**Bulker Q&As and CIs on the IACS CSR Knowledge Centre**

Figure 3: Definition of hot spot stress at an intersection of two plates

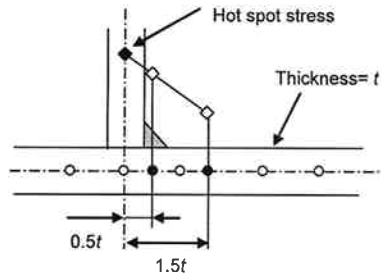
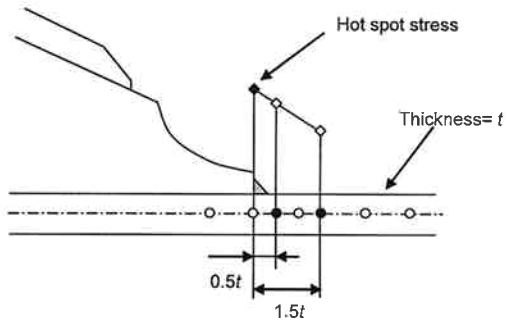
The hot spot stress in a very fine mesh is to be obtained using a linear extrapolation. The stresses located at 0.5 times and 1.5 times the net plate thickness are to be extrapolated at the hot spot location, as described in Fig 3 and Fig.4.

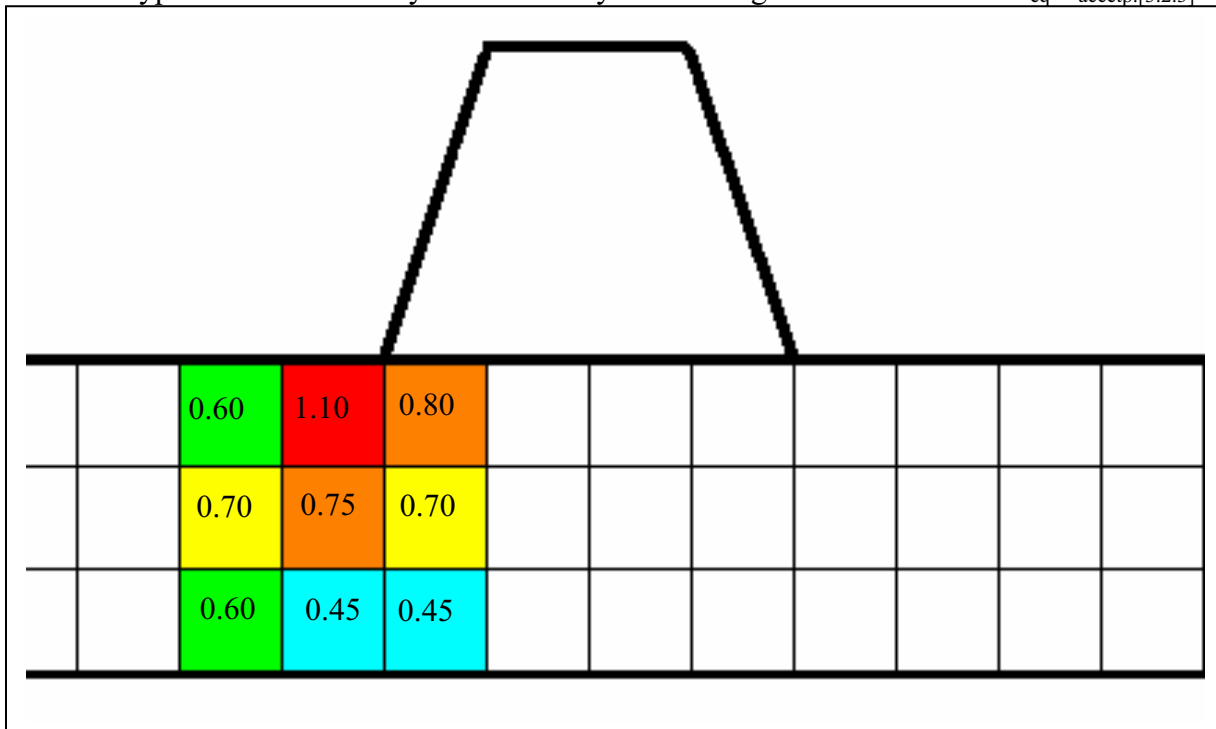
Q1: We assume item [3.2.3] is referring to membrane stress only. That is, local plate bending is neglected. Please confirm.

Q2: We assume the acceptance criteria of Ch. 7 Sec. 2 [3.2.3] is related to an element size of  $S \times S$ . That is:

Q3: A typical connection of a longitudinal girder to the lower stool is shown in the figure below. A typical utilization for yield in a heavy ballast cargo hold is indicated  $\sigma_{eq}/\sigma_{accetp.[3.2.3]}$ .

Assuming all 3 elements are equally sized over the height of the double bottom as indicated on the figure. What is the correct application of [3.2.3]?:

- a. Each individual element over the height has to be within the requirement of [3.2.3]. That is, the red element has to be reinforced until the utilization is < 1. ?  
or
- b. The results may be averaged over a typical stiffener spacing,  $S \times S$ , in the double bottom as indicated with grey in the below figure. The averaged utilization should be < 1?

Assuming the 3 elements are slightly different in size. What is the correct application of [3.2.2]?:

- c. Each individual element over the height has to be within the requirement of [3.2.3]. That is, the red element has to be reinforced until utilization is < 1.?  
or
- d. The results may be averaged over a typical stiffener spacing,  $S \times S$ , in the double bottom. The averaged utilization should be < 1?  
or
- e. The results may be averaged based on an element size =  $H_{dblBottom}/3$ ?

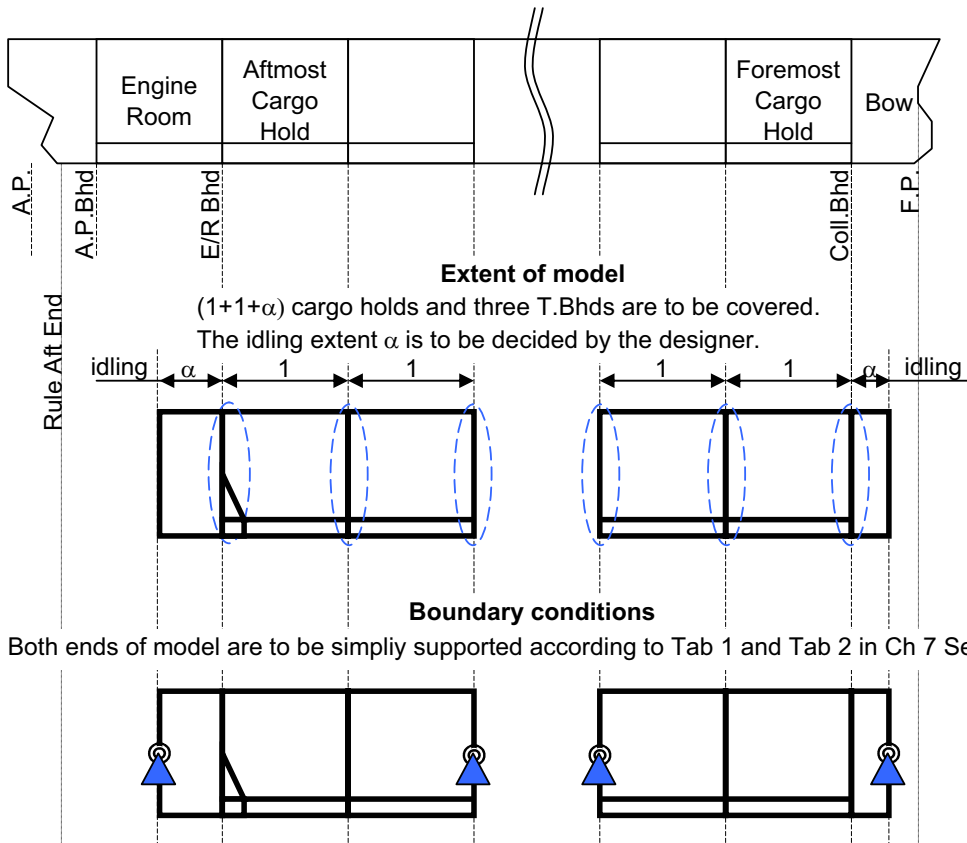
2. Is the correction factor of Ch7, Sec4, 3.3.2 to be applied to only the intersection of two plates or both the intersection of tow plates and intersection of plating and bracket?

3. If stress of no1 element is slightly greater than no2 element, is the correction factor of Ch7, Sec4, 3.3.2 still to be applied?
